ADDENDUM #02
TO
INVITATION TO BID #01

March 14, 2018

WESTERN CONNECTICUT STATE UNIVERSITY
RENOVATIONS TO
HIGGINS HALL & HIGGINS ANNEX

STATE PROJECT NO: BI-RD-290-CMR

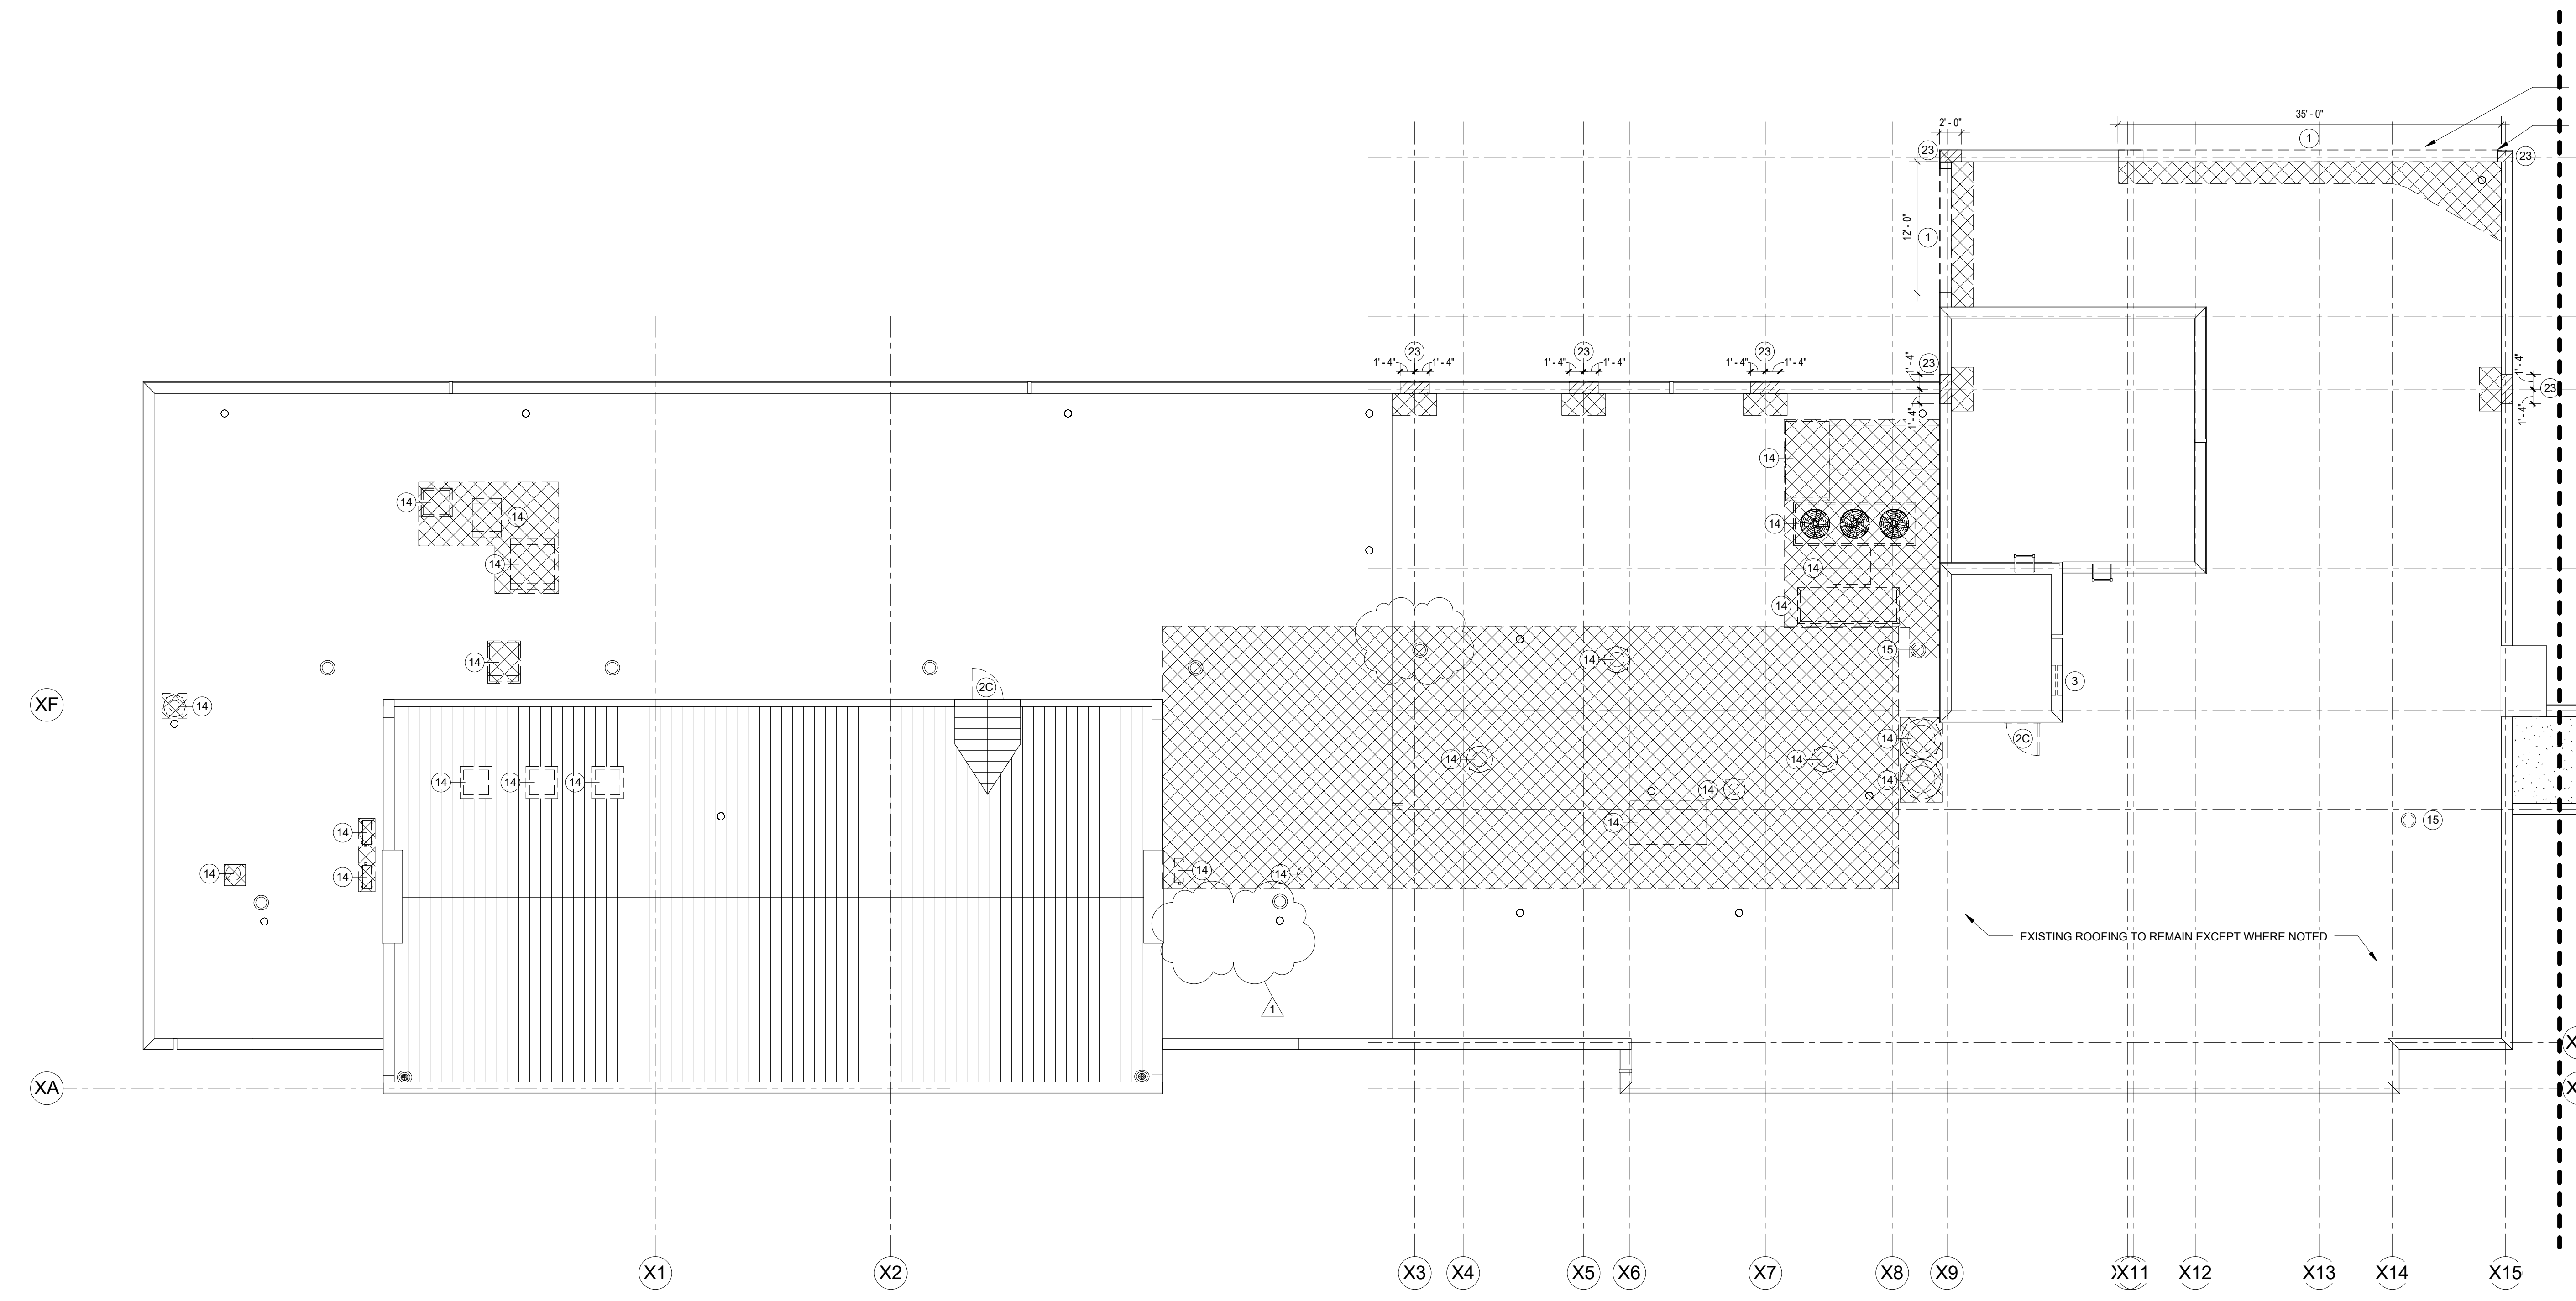
1. Add demo note #12C -REMOVE CEILING AND SUPPORTING STRUCTURE. PROTECT GWB SOFFITS. SALVAGE / PROTECT EXISTING LIGHT FIXTURES, PROJECTION SCREEN, SPEAKERS, DIFFUSERS ETC. AND REINSTALL.
2. Change demo note #13 to - REMOVE LIGHT FIXTURES (ALL EXTERIOR FIXTURES TO BE SALVAGED AND RETURNED TO THE OWNER)
3. Change demo note #14 to - REMOVE ROOF UNIT, UNIT CURB AND ALL ASSOCIATED FLASHING, BLOCKING ETC.
4. Change demo note #15 to - REMOVE ROOF DRAIN
5. D1.21B:
 - Replace drawing with revised D1.21B.
6. D1.31A:
 - Replace drawing with revised D1.31A.

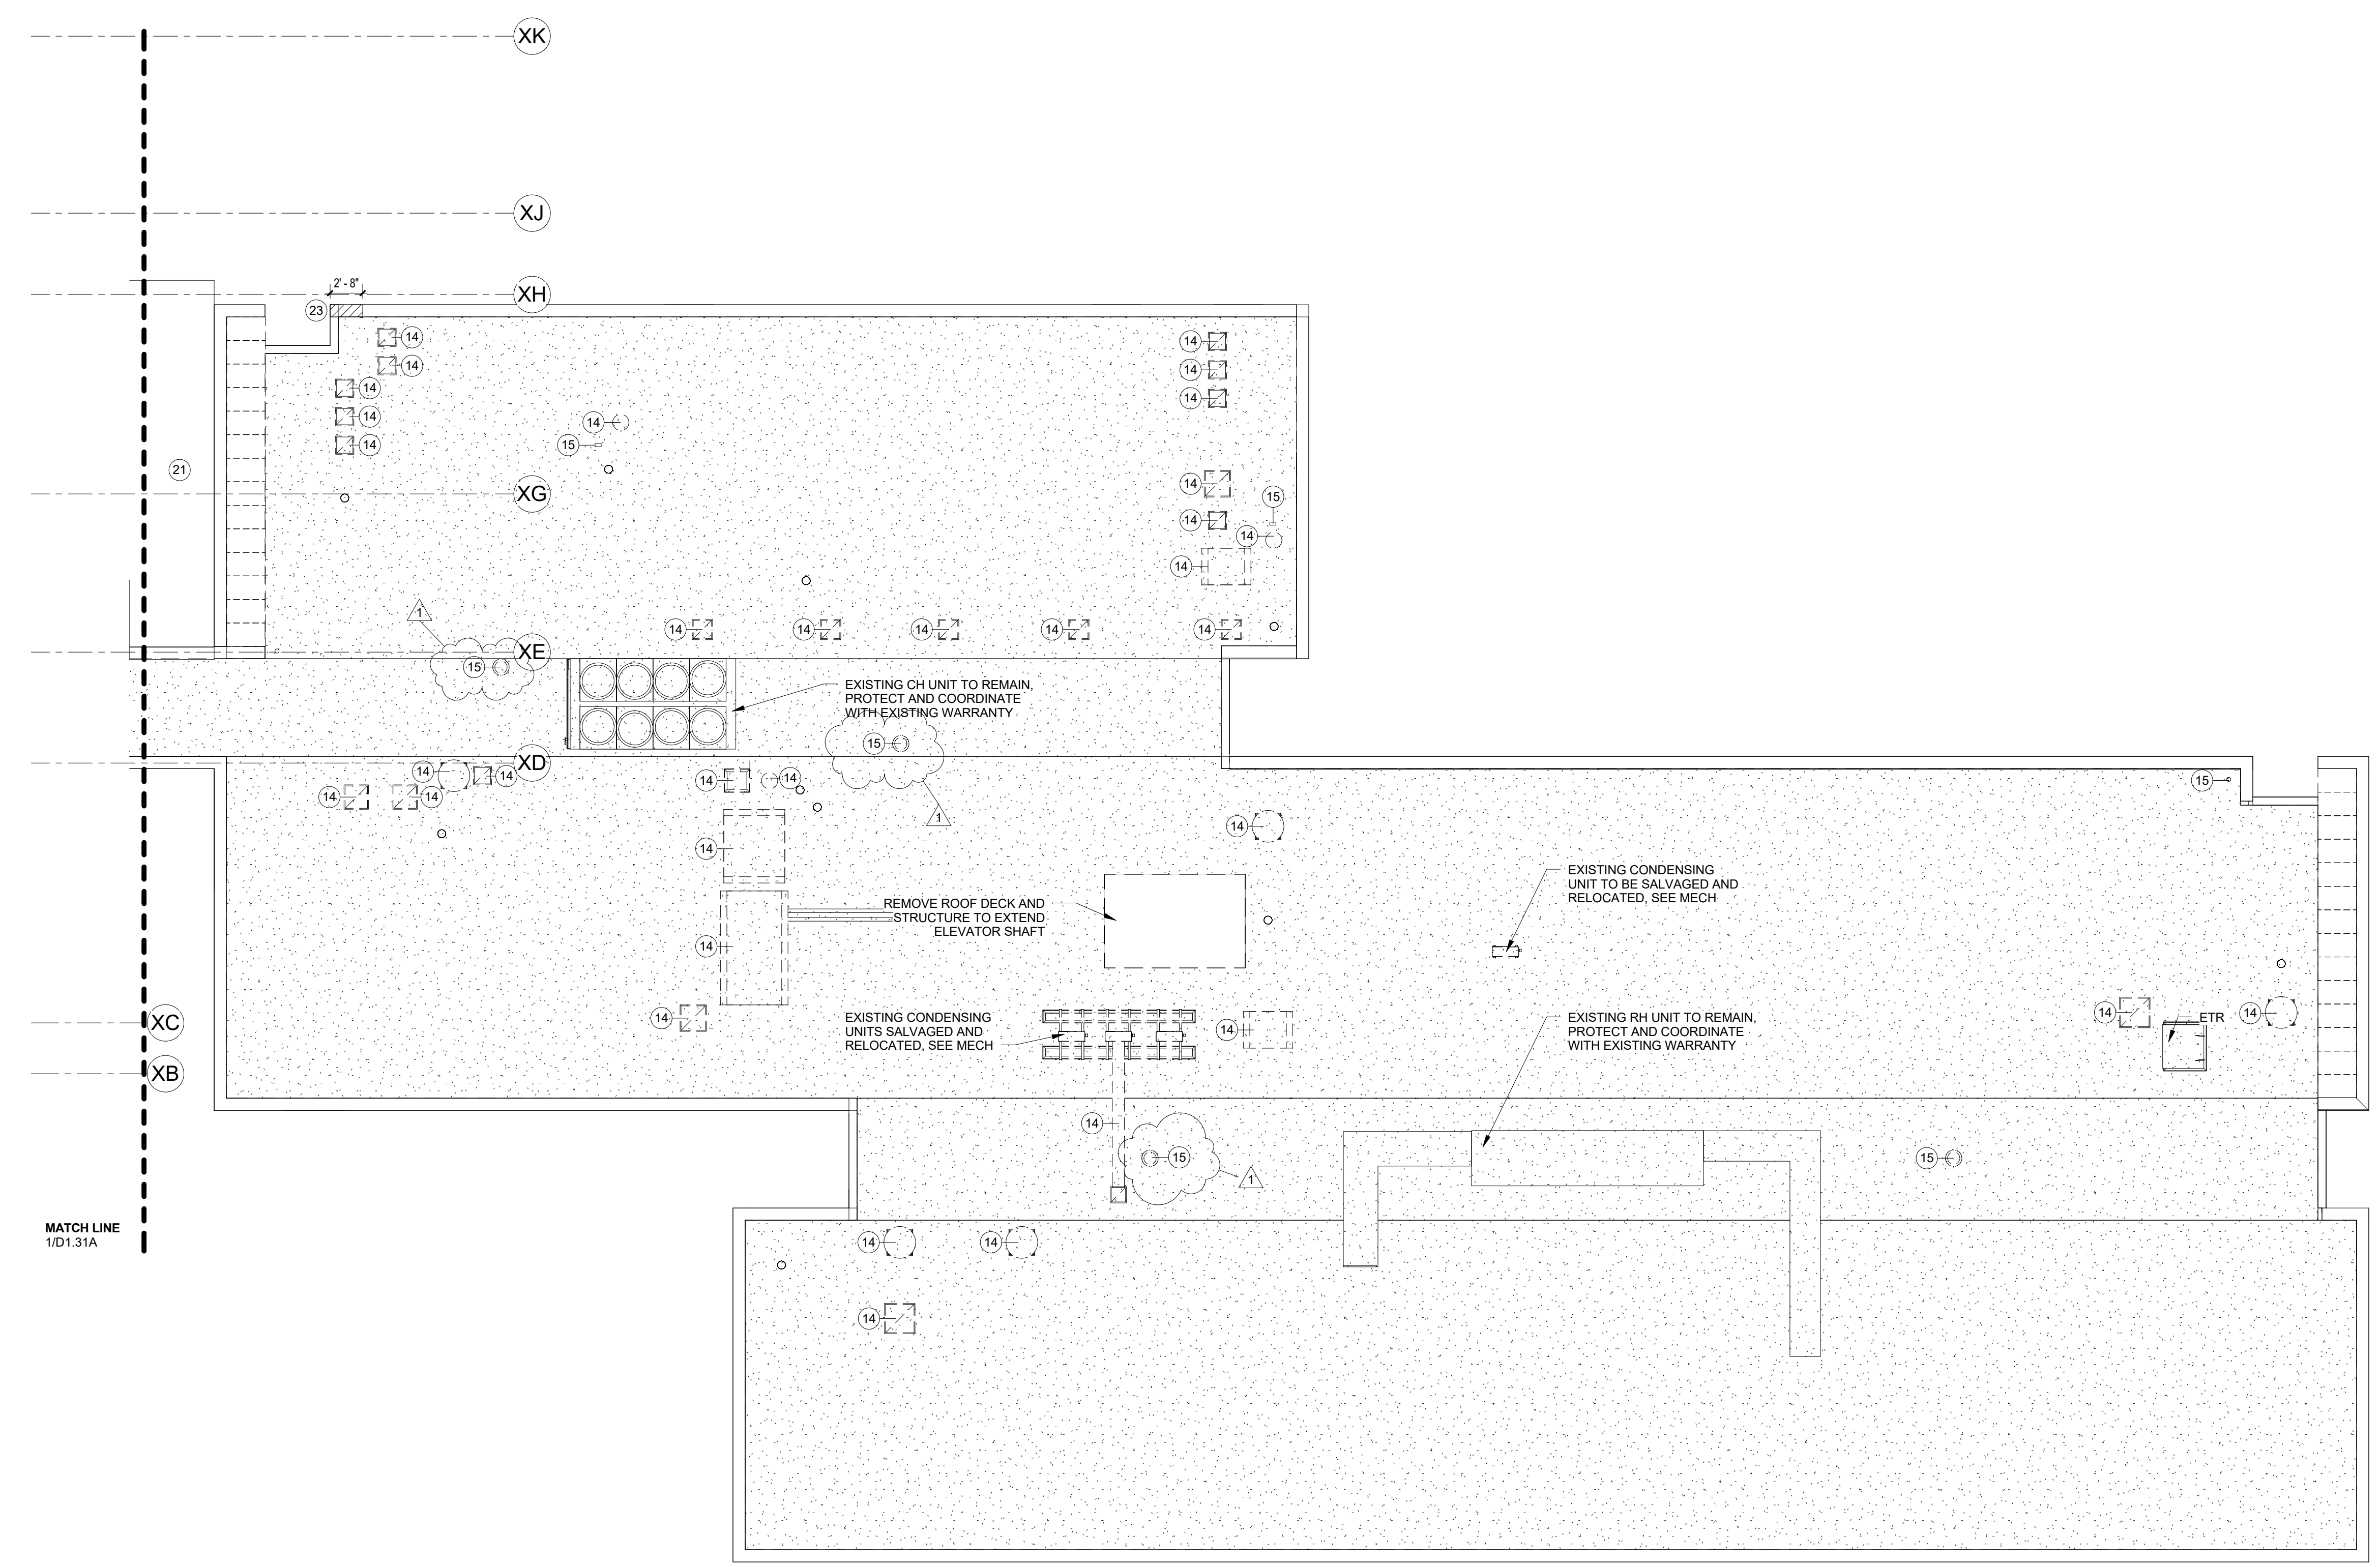
- RFI Question** – Is there a detail to cap existing mechanical equipment that is removed? Note 14 on Demo Dwgs Roof Plan
- Answer* – All mechanical equipment including the curb and associated flashing to be removed. Area to be infill with new structural infill and insulation matching the existing and covered with new roofing. Refer to updated notes on roof demo and construction plan. TSKP 03/12/2018.

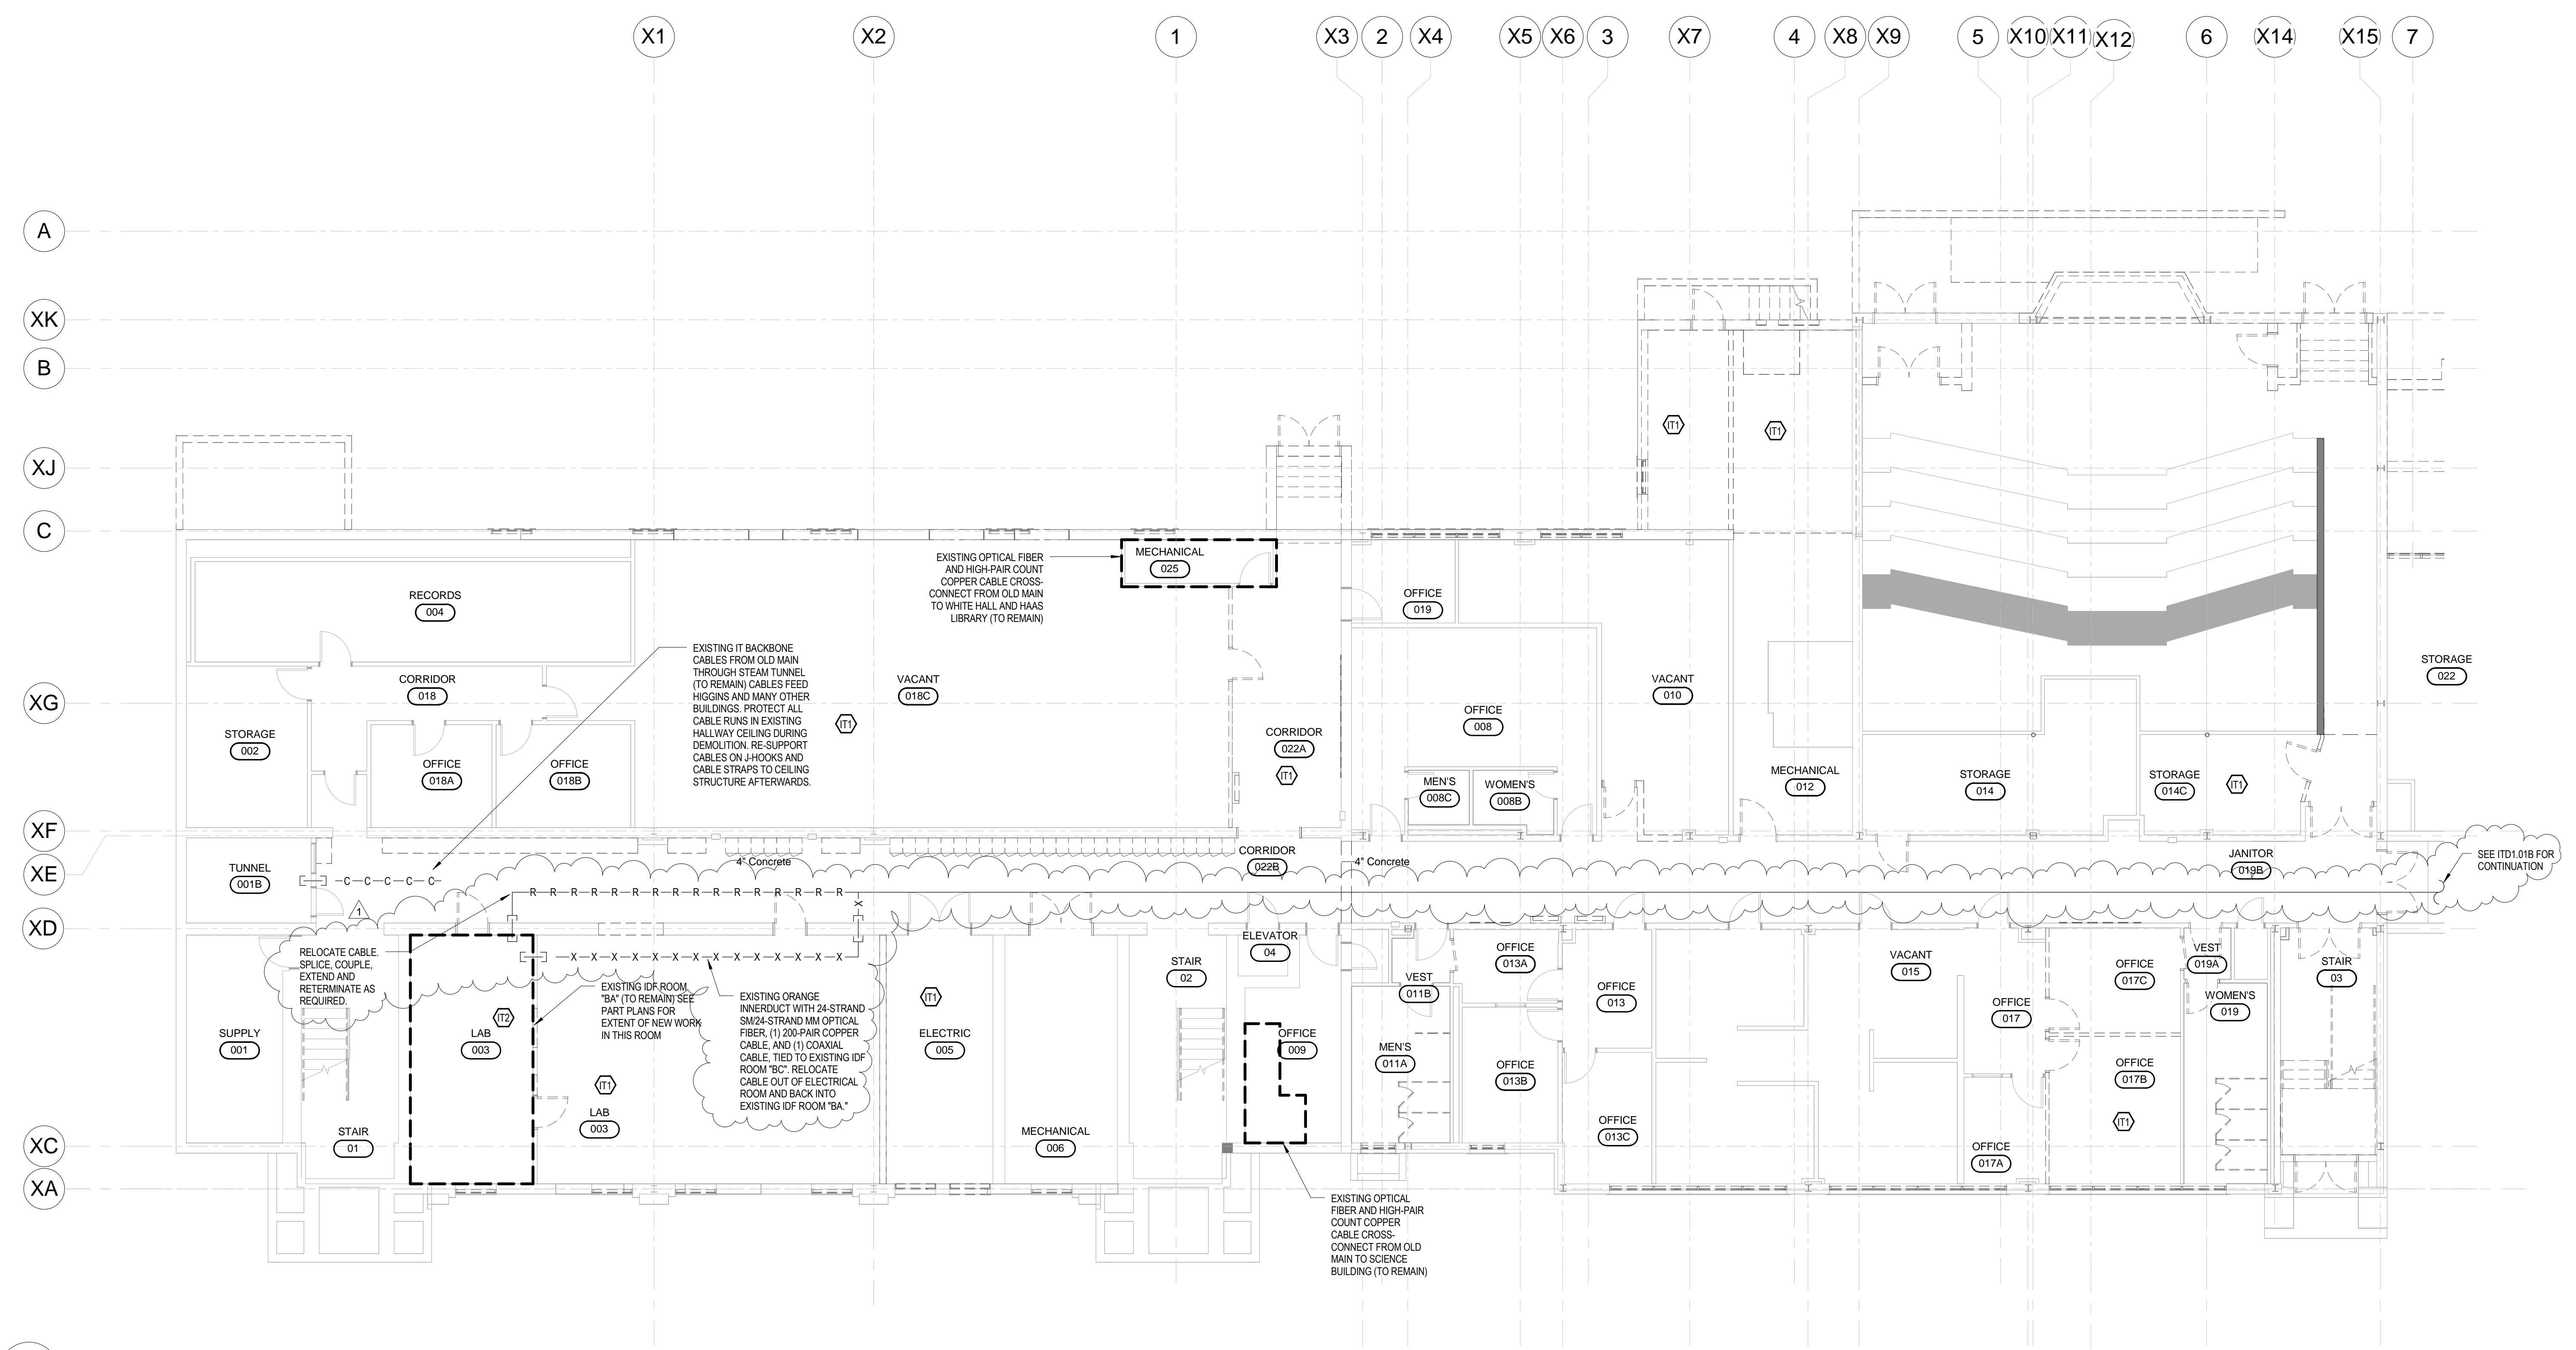
- 17. ITD1.01A:
 - Replace drawing with revised ITD1.01A.
- 18. ITD1.01B:
 - Replace drawing with revised ITD1.01B.
- 19. IT1.01:
 - Replace drawing with revised IT1.01.
